ADDENDUM

ADDENDUM NO.: 02
PROJECT NAME: Kenwood Academy Link and Mechanical (Rebid)
PROJECT NO.: 05326
CONTRACT NO.: C1602R
DATE OF ISSUE: February 29, 2024

NOTICE OF CHANGES, MODIFICATIONS, OR CLARIFICATIONS TO CONTRACT DOCUMENTS

Sheet: **A605**

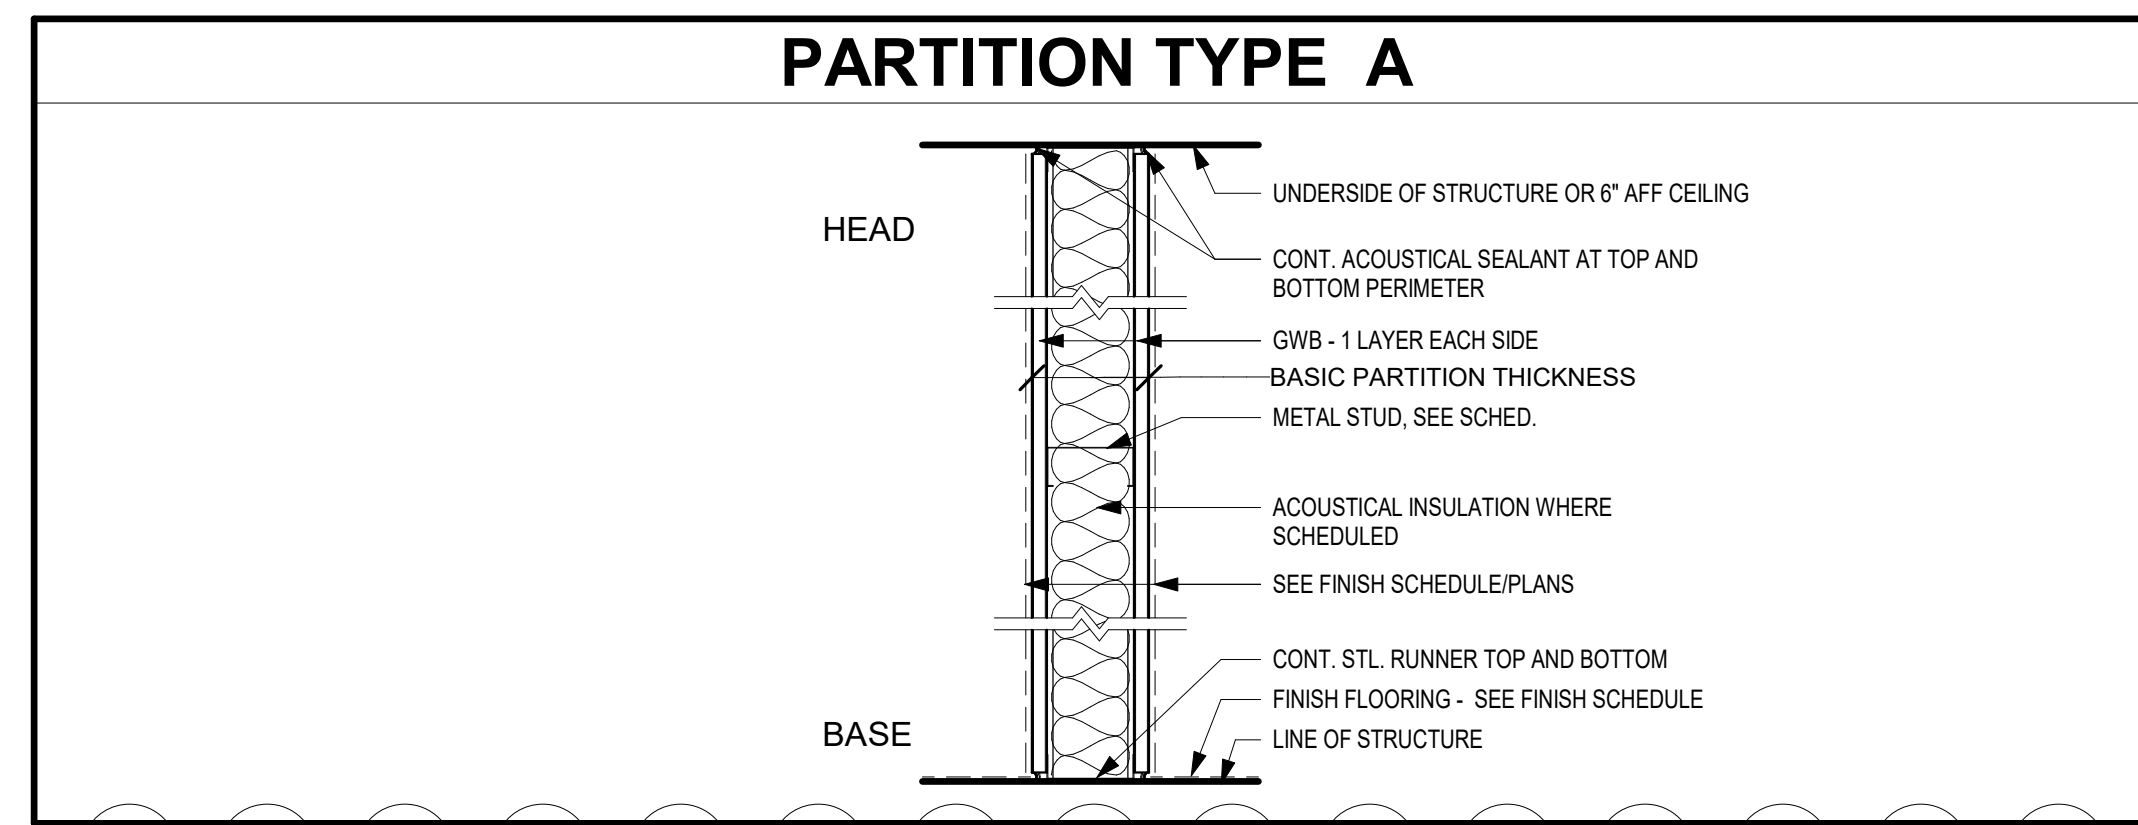
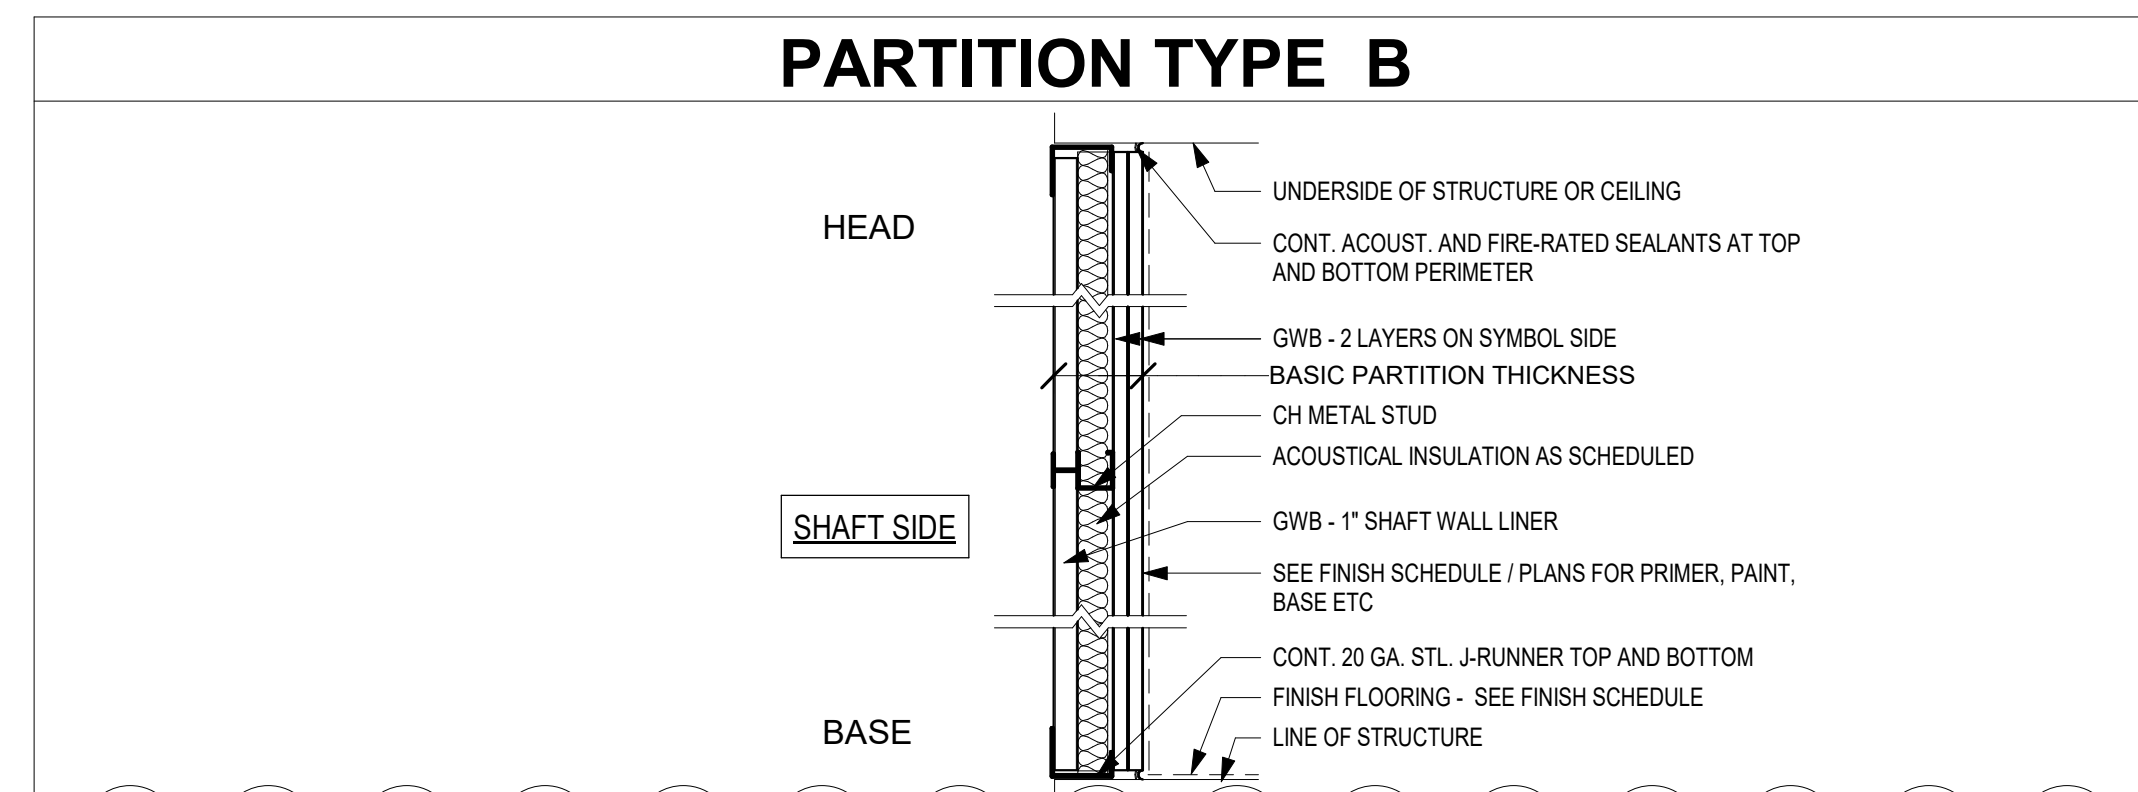
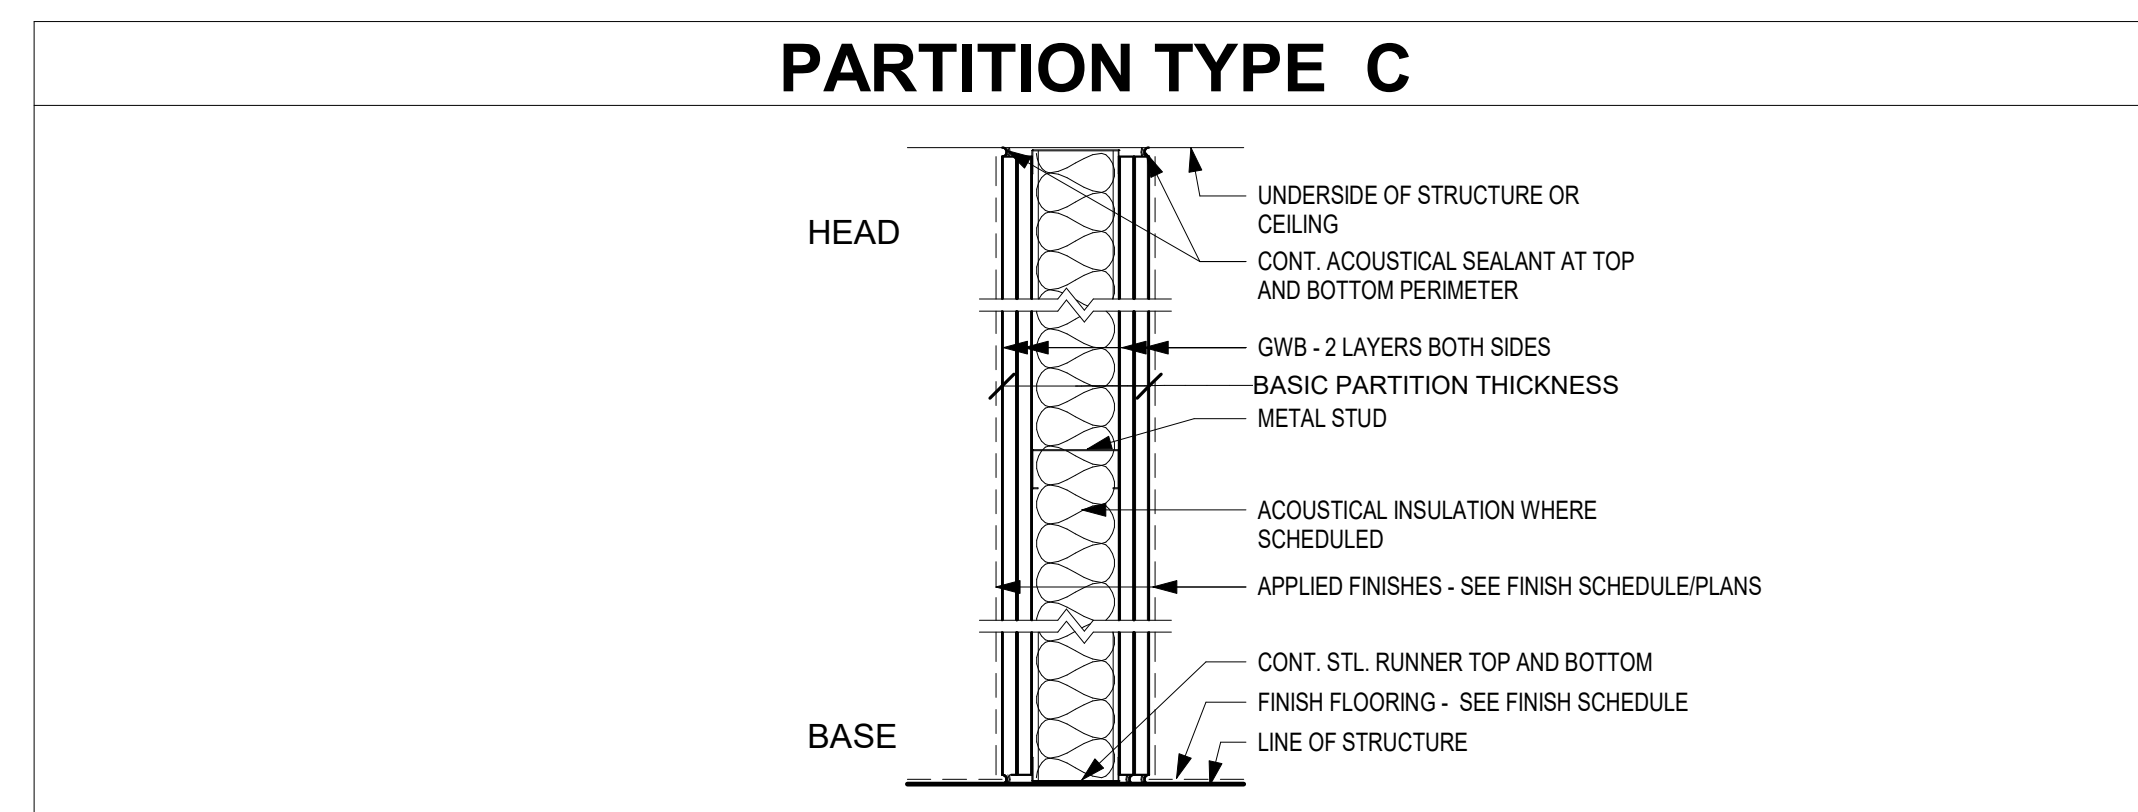
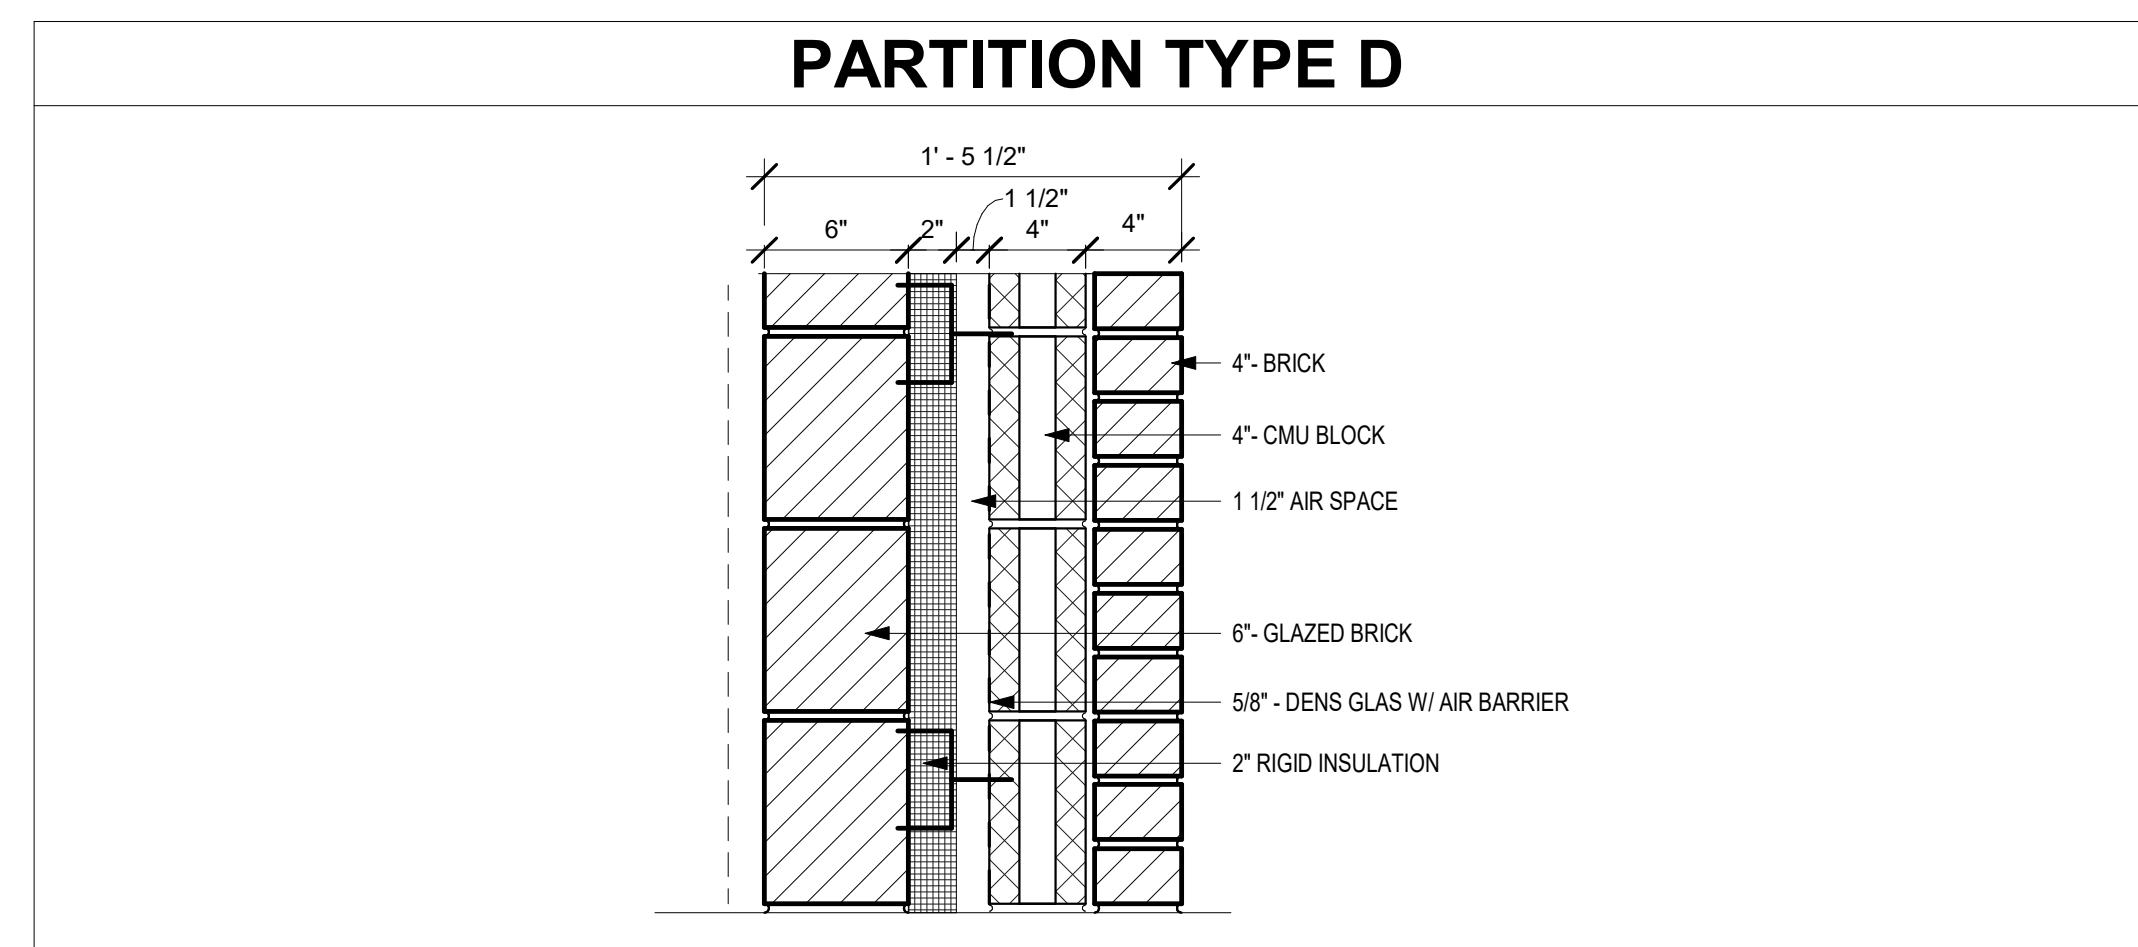
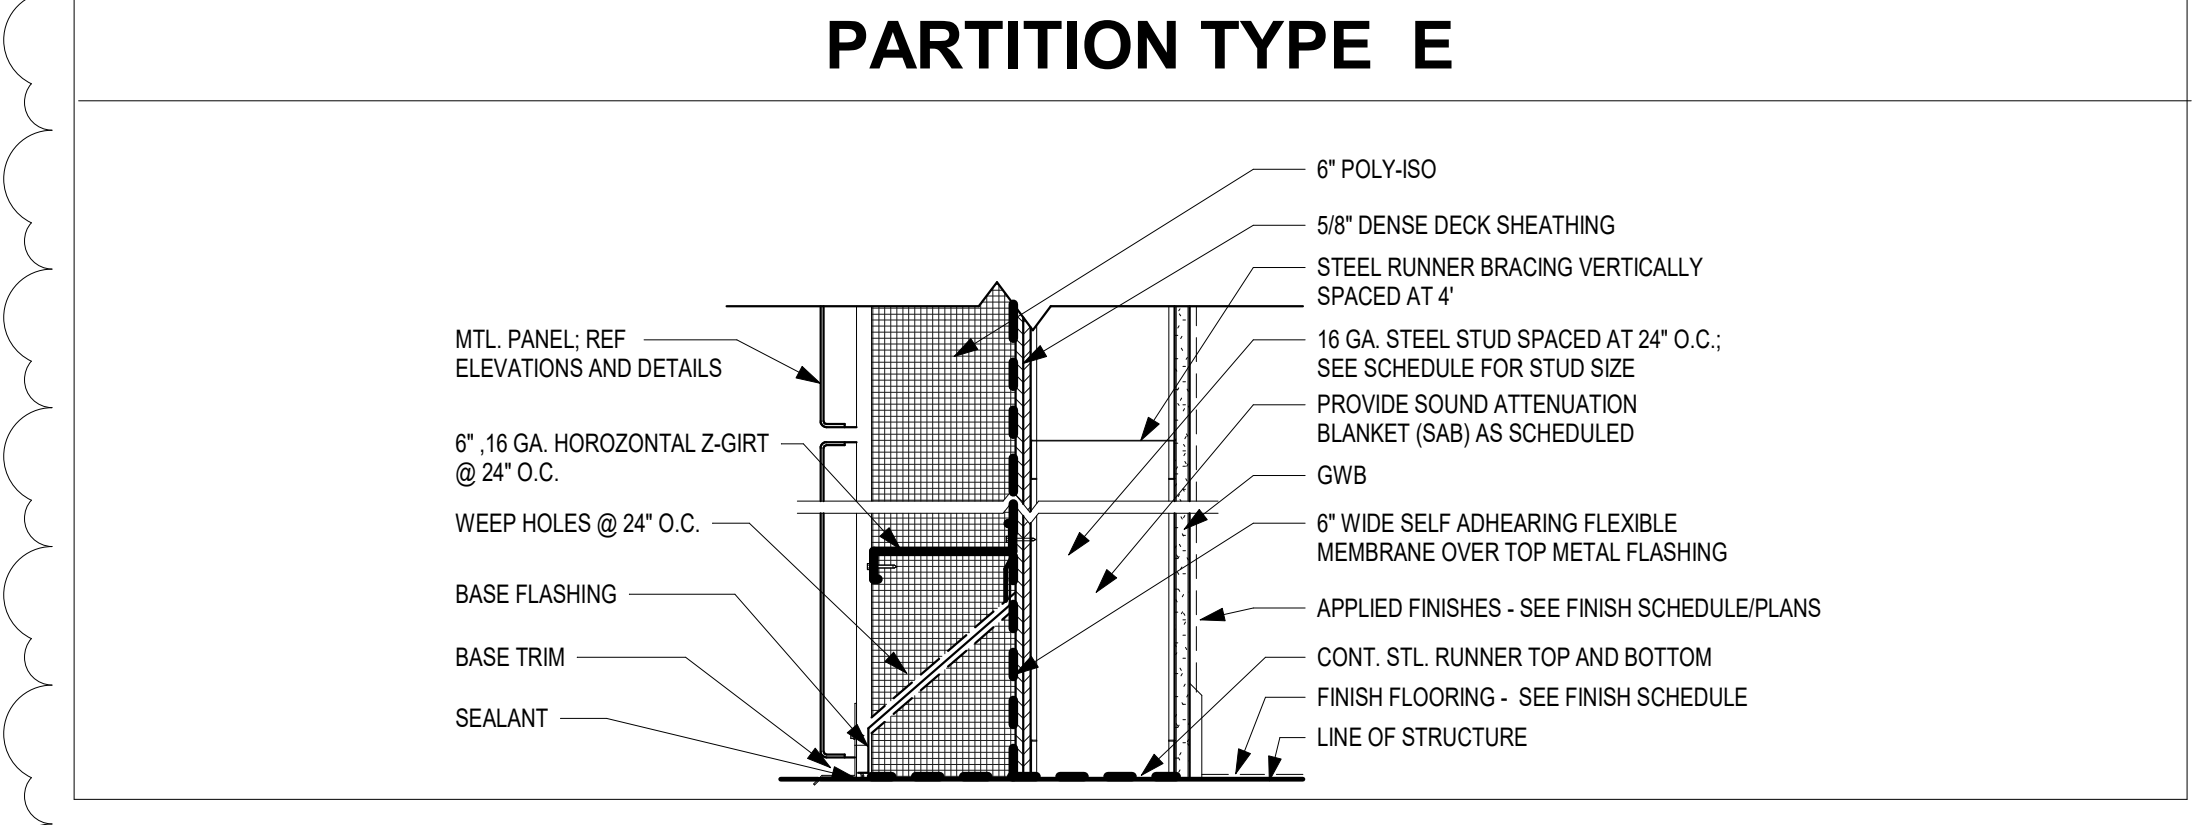
- Change 10** A201 - ENLARGED ELC- ROOM PLAN, SCHEDULES AND DETAILS; **REVISED** to add additional notations regarding demolition plan
- Change 11** A605 - PARTITION TYPES; **REVISED** to add information regarding partition types and add partition type E.

Question: (Regarding Partition Types) Please note that the exterior walls/partitions in the link are not identified by partition type. Some walls are 6" CFMF and others are 8" CFMF. Can you identify which walls 6" and/or 8" by a wall type?

Question: (Regarding Partition Types) To determine the depth of the solid surface sills 5 3/4" or 7 3/4" it would be helpful to know the stud size per wall type.

Question: (Regarding Partition Types) Sheet A605 "Partition Type" is missing information for all partition types. Please reissue.

Response: [All exterior Wall Types are the same construction type. 8" metal studs have a 6" HSS structural column inside the wall. 6" metal stud walls do not have a column inside. Please refer to sheets A110, A111, and A605 revised and included in this addendum.](#)

Response: [E1 partitions to have 5 3/4" sill depth and E2 partitions to have 7 3/4" sill depth. Please refer to sheets A110, A111, and A605 revised and included in this addendum.](#)

Response: [Please refer to sheet A605 revised and included in this addendum.](#)
